02 PROPOSED ROOF PLAN
21-803 Scale 1:50

01 PROPOSED THIRD FLOOR PLAN
21-803 Scale 1:50

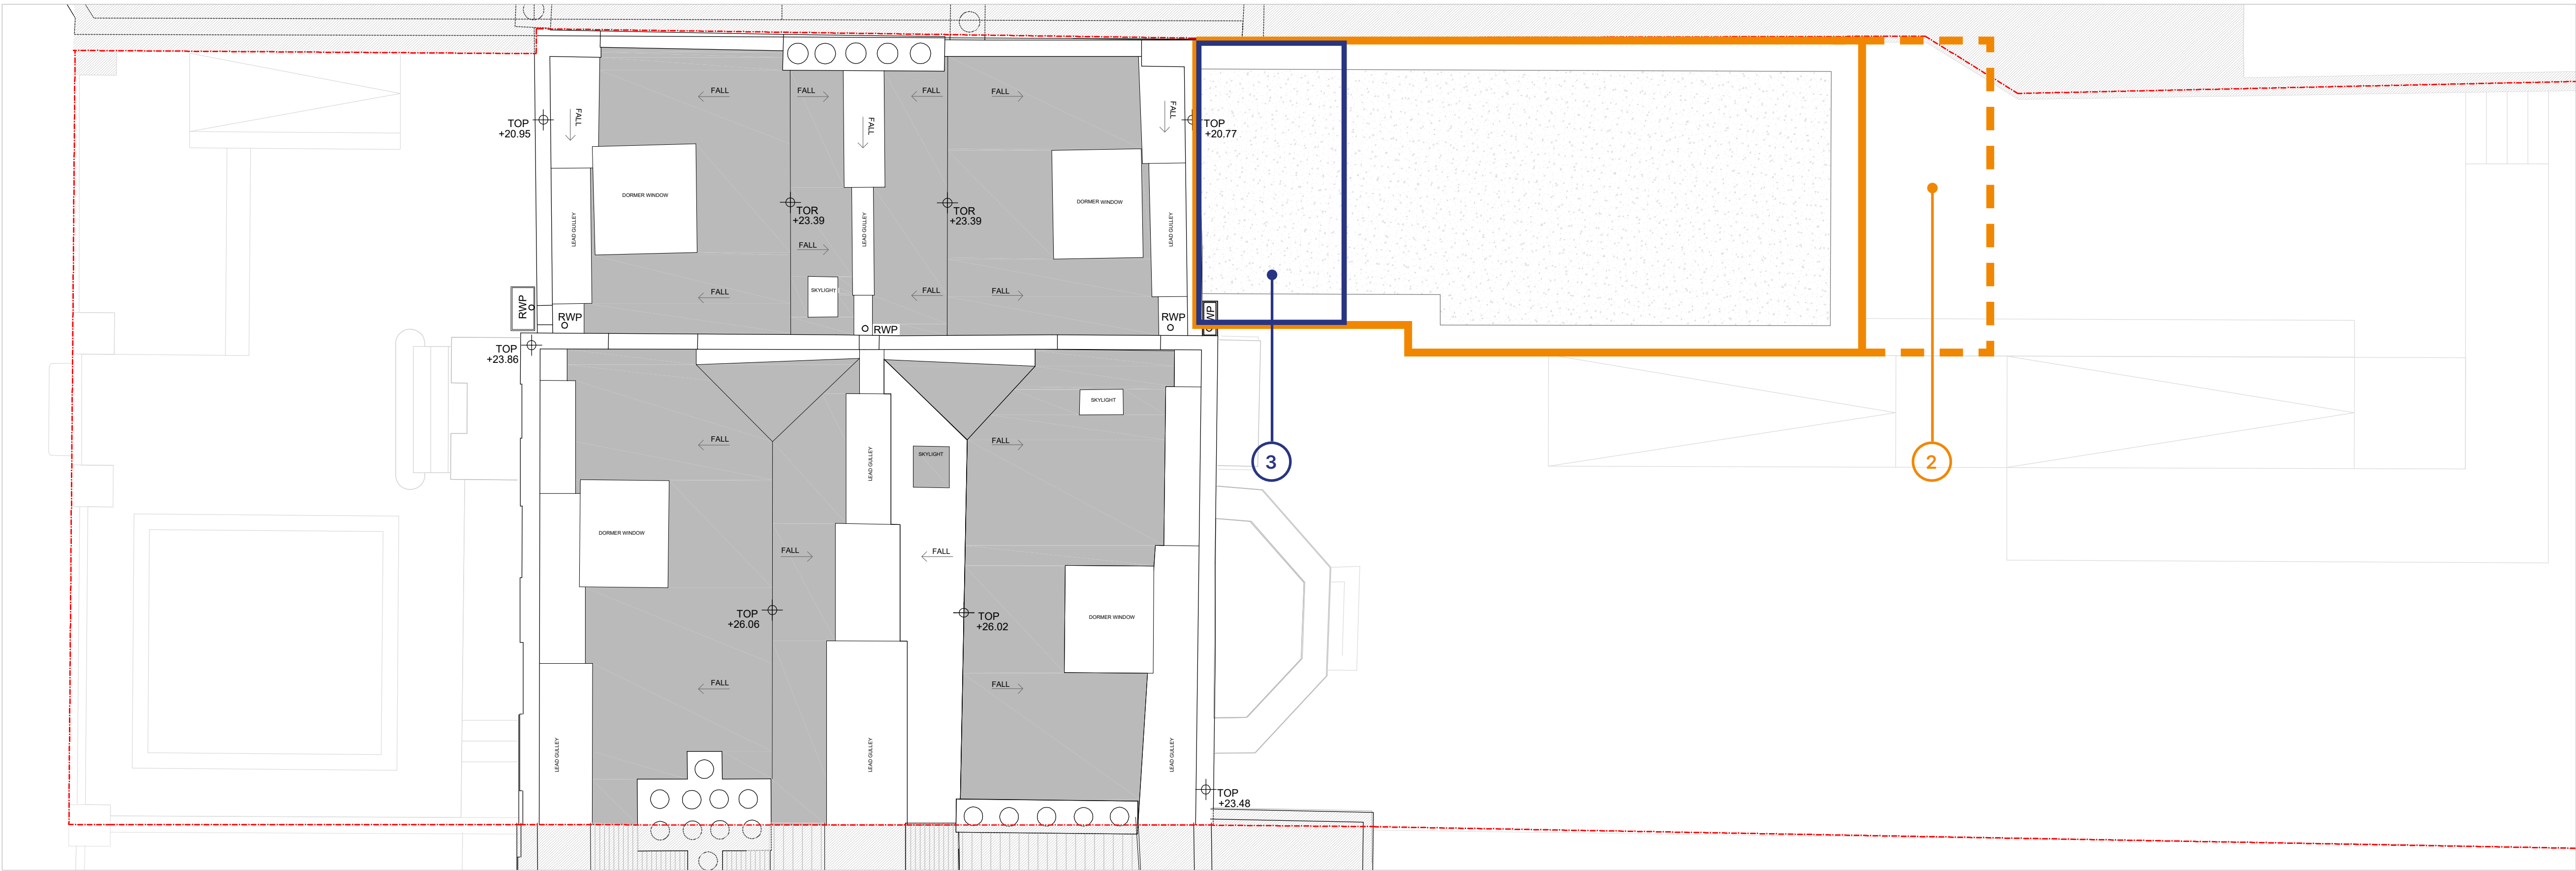
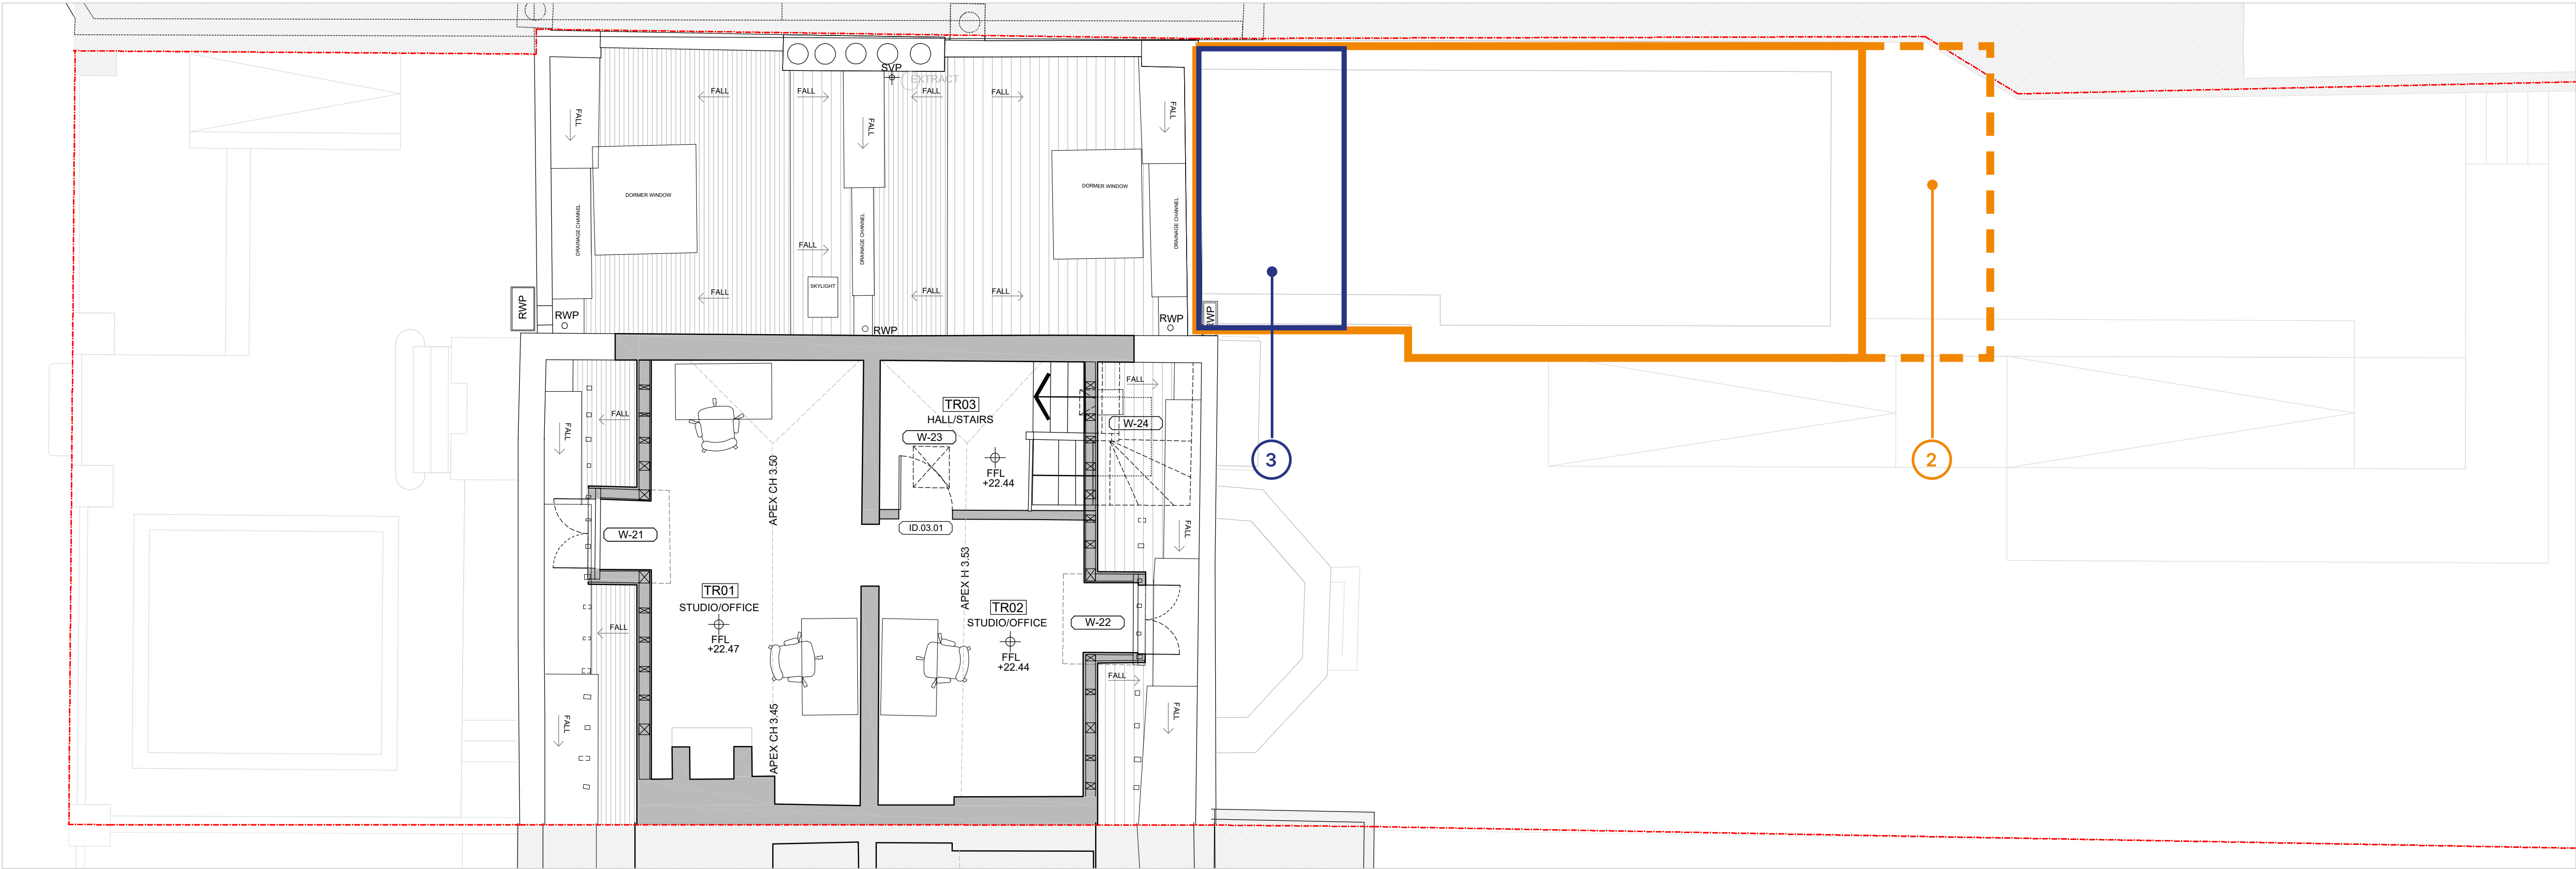
- Existing floor level retained, steps and platform lift omitted – rear addition façade extended down to ground level.
- Consented single storey rear addition extended by 1.5m, to the east.
- Junction between existing building and rear extension altered with addition of glazed link – associated roof geometry altered.
- Landscaping revised to suit café extension at grade level.
